FCC CLASS II PERMISSIVE CHANGE REQUEST LETTER

**RE: FCC Permissive II Change Request for Company : Sasse Elektronik GmbH
FCC ID : UXA-990516X**

- Transceiver Module TM2.4-1 Model-No. 1350.9905162
- Transceiver Module TM2.4-2 Model-No. 1350.9905161

Figure 1: Block diagram

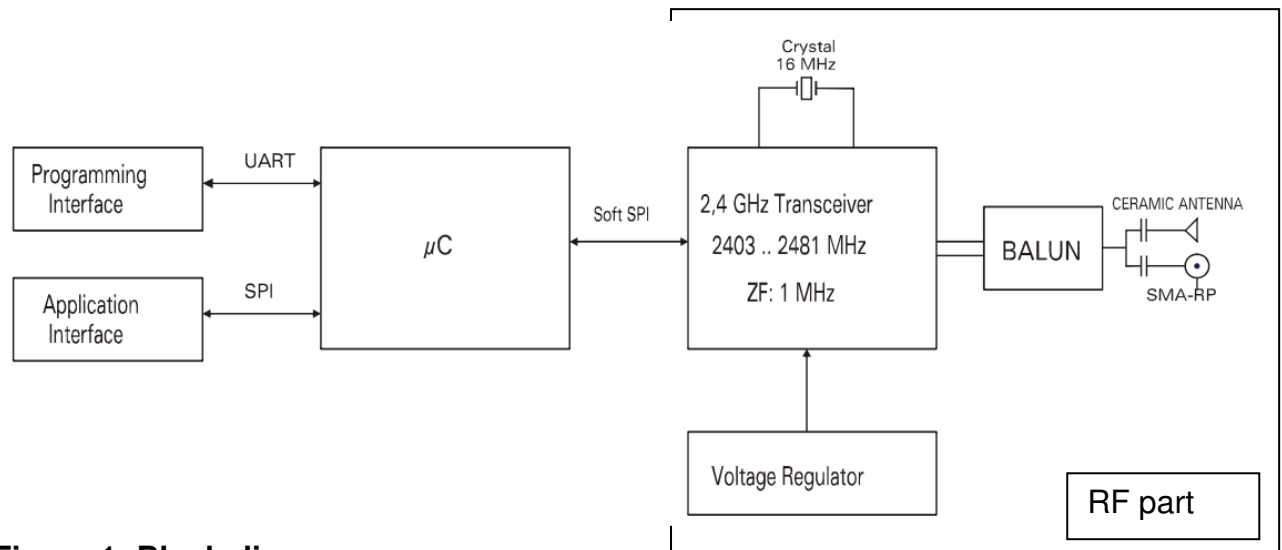
The interface microcontroller has been replaced by another type.

The RF part and the mechanical dimensions have not been changed (no changes in PCB layout and components of the RF part).

The current 8-bit microcontroller of type NXP 89LPC932 has become obsolete.

This microcontroller has been replaced by type:

- STM32L051K6 from ST Microelectronics

The RF part of the transceiver module has not been changed (no changes in PCB layout and components of the RF part).
